**Project: Conditional Use Permit (CUP) No. 21-001, Tentative Tract Map No. 24-001 (TTM 84317),
General Plan Amendment (GPA) No. 21-001, and Zone Change (ZC) No. 21-001**

SUBJECT: CONDITIONAL USE PERMIT No. 21-001, MITIGATED NEGATIVE DECLARATION, SCH #2024080570, LOS ANGELES COUNTY, CA

Re: Comments on the Draft Mitigated Negative Declaration for Conditional Use Permit
No. 21-001 (SCH No. 2024080570)

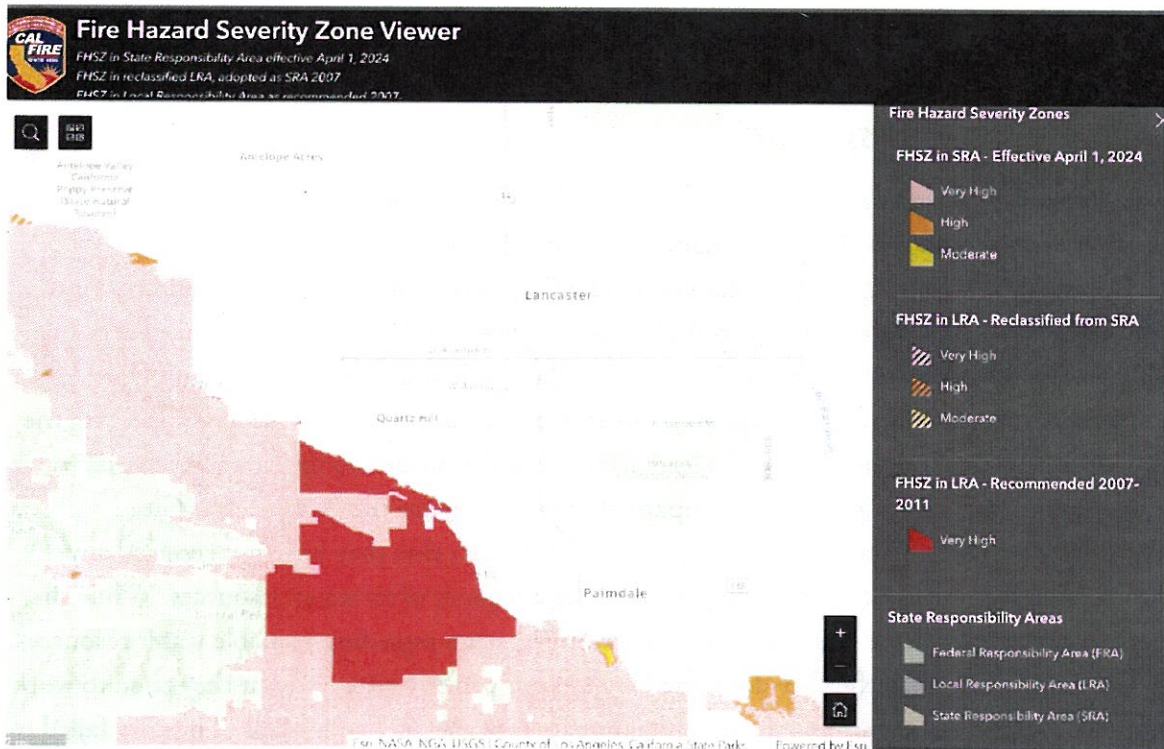
The four adopted significance thresholds for wildfire impact revolve around the overarching determination of whether the Project is “located in or near state responsibility areas or lands classified as very high fire hazard severity zones.” (MND, p. 52 [emphasis added].) The City determined that the Project would have no wildfire impact because the Project site is not in a very high fire hazard severity zone or state responsibility area. But the City did not provide any information to prove the veracity of this statement, nor did it attempt to define the scope of what “near” means in the context of a very high fire hazard severity zone (VHFHSZ).

The City failed to acknowledge that there is evidence that the Project is located near land which is classified as a very high fire hazard severity zone. The figure below shows Fire Hazard Severity Zones (FHSZ) data in the State Responsibility Area (SRA), effective April 1st 2024 in the area surrounding the Project site.²²

By constructing a mixed-use development, the Project will undoubtedly add to risk of wildfire, both within the Project Site and in areas adjacent to the Project Site, but the City did not reach any of the significance thresholds within the overarching preliminary wildfire threshold because it incorrectly determined that the Project is not near a VFHSZ.
